# Product Change Notification

<b>Date Issued :</b>	May 27, 2022	<b>PCN Number :</b>	512108
<b>Reason for Change :</b>	Obsolete		
<b>Description of Change :</b>	This notification is to inform you about the Obsolescence of parts(s) referenced in this notice. Please connect with your Molex Sales Engineer for additional queries related to possible replacement part(s).		
<b>Reason for Short Notice :</b>	Force Majeure		
<b>Planned Implementation Date :</b>	September 20, 2022		
<b>Recommended replacement parts :</b>	Please see the attached replacement parts list .xls file.		
<b>Last Time Buy Date for Obsolete Parts :</b>	June 20, 2022		
<b>Last Time Ship Date for Obsolete Parts :</b>	September 20, 2022

## SFP+/ZSFP+ Ganged Cage

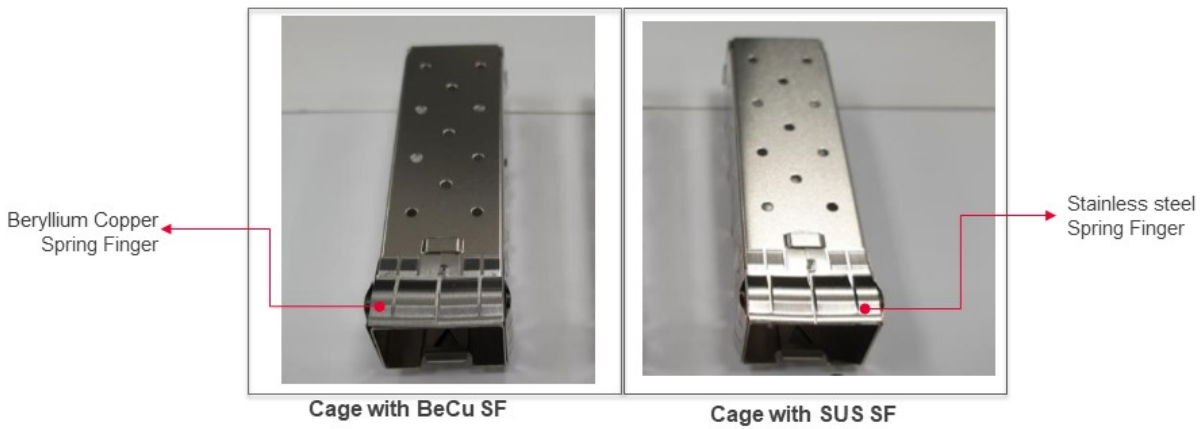
- Please be advised that the following Part numbers from the SFP+/ZSFP+ Ganged cages product families are being made Obsolete with replacement. The spring fingers of the offered replacement parts will be made of Stainless Steel.

- Reason for Change
  - Critical shortage of Beryllium Copper which is the raw material used in spring fingers of the affected parts.

- Product Impact
  - No impact to fit ,form or function based on test summary 747548001 (available upon request).
